City of Oxford
Community Development Department
STAFF REPORT

Board of Zoning Appeals

Case # BZA-2016-08

Case # BZA-2016-06 – Revised Report

CROSSWALK CONCRETE PAVEMENT DETAIL

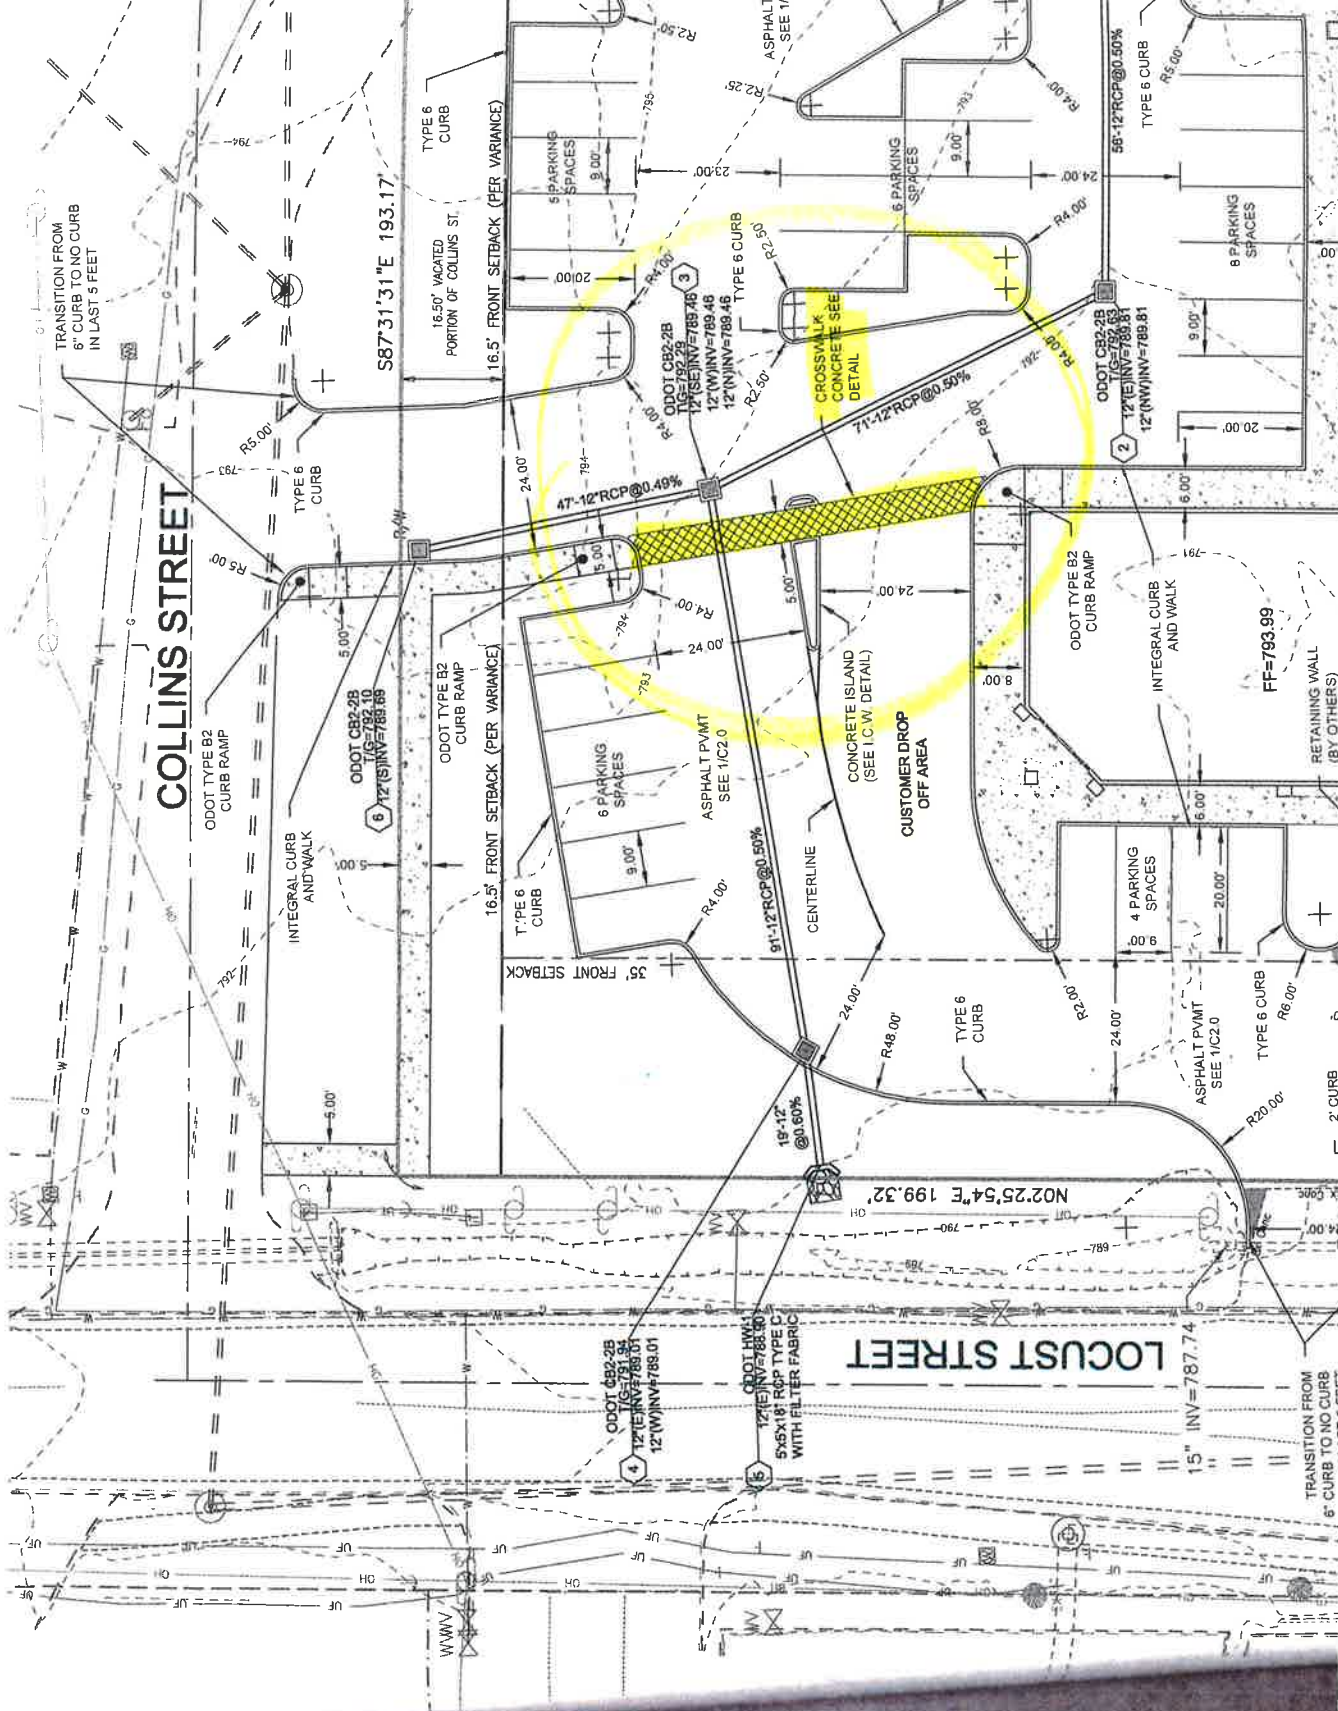
The current walkway is surface-applied stripes, which, according to the above code section is not sufficient marking.

The Goodwill building permit application was submitted August 2015 after the new code was in place in April 2015. The plan approved in October 2015 included a code compliant pedestrian crossing. (See enclosed excerpt from plans) The designer chose concrete to differentiate from the asphalt parking. The Certificate of Occupancy for building code compliance was granted in May however the Certificate of Code Compliance from all city departments has not been issued due to the non-compliance with zoning. The owner has opted to seek a variance rather than correct the issue in the field.

After the Certificate of Occupancy was issued, my client and I received an email from Sam Perry on May 5, stating that the pedestrian crossing of the parking lot should be concrete, per approved plans, not asphalt with striping.

Staff recommends denial of this variance request because of insufficient evidence to warrant the variance.

A-1

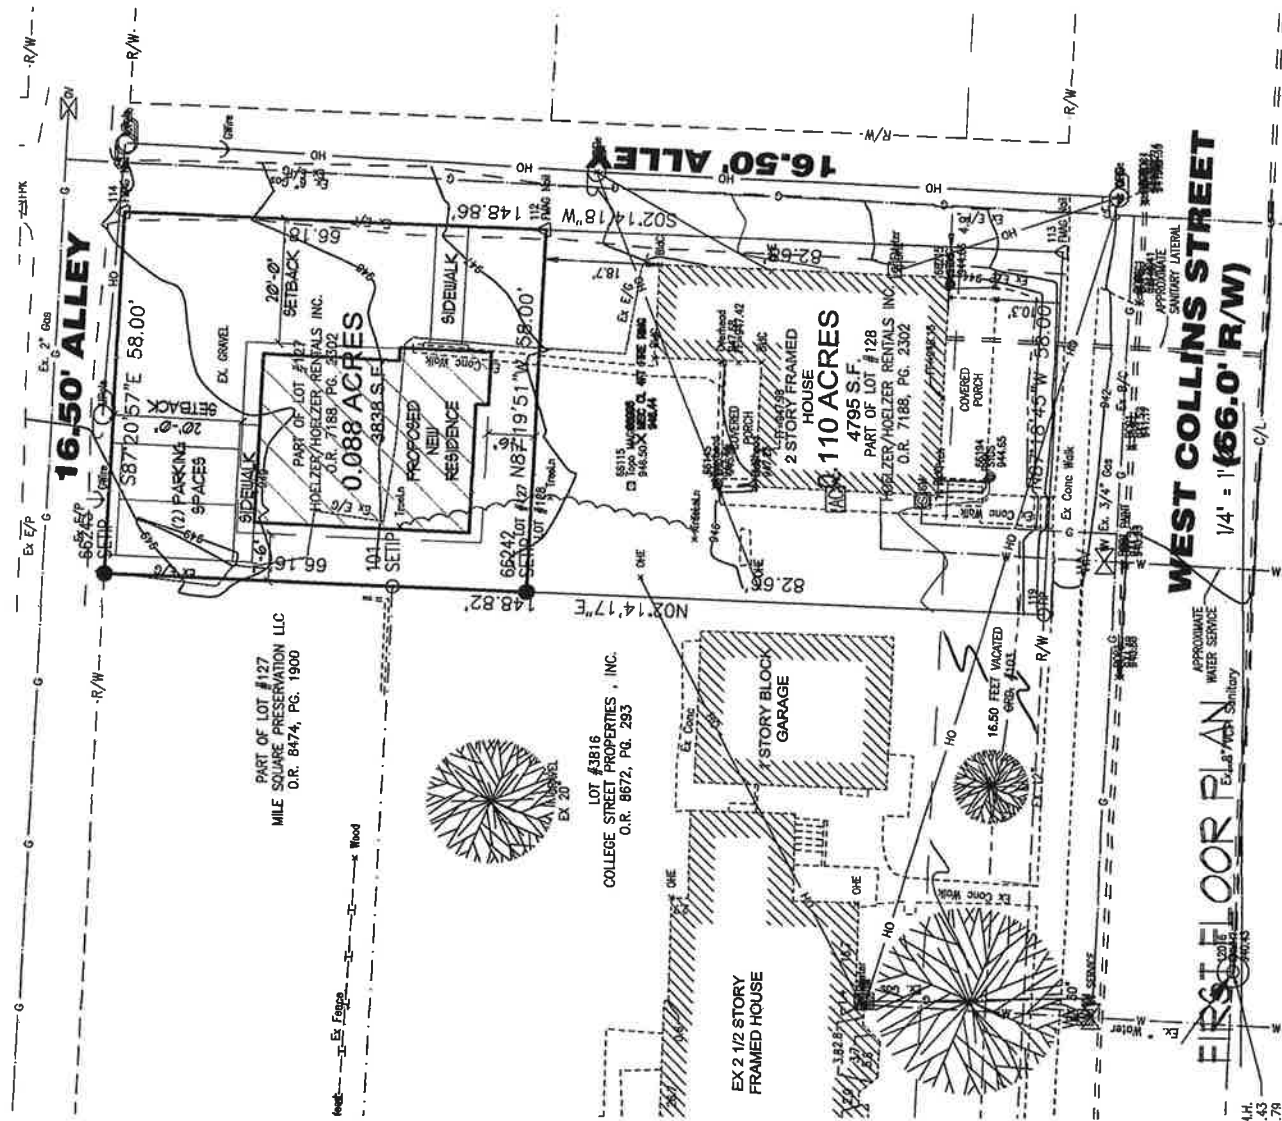
The alley lot location prevents a new building on the subject lot from meeting this requirement

The proposal requests relief from the restriction of no more than one in the front yard, to allow two.

Regarding criterion C, Staff believes that the variance **would negatively alter the essential character** of the neighborhood because there are no other principal buildings with alley entrances in this block.

Regarding criterion D, Planning staff believes that the **delivery of governmental services would be more limited** by the granting of these variances. However the City Engineer, Fire Chief and Police Chief have not commented on this issue. Alleys were originally designed for secondary access and now are also used for some utilities such as overhead lines. Streets afford more than two times the width of alleys for governmental services to be delivered.

If the BZA determines that difficulties exist which are sufficient to warrant the variances, the staff recommends that the BZA cite any new or different specific evidence not yet identified and approve the variance requests. At the time of this report, **staff believes there is not substantial evidence that supports the variance requests.** If the BZA does approve the variances it can attach any appropriate conditions necessary.
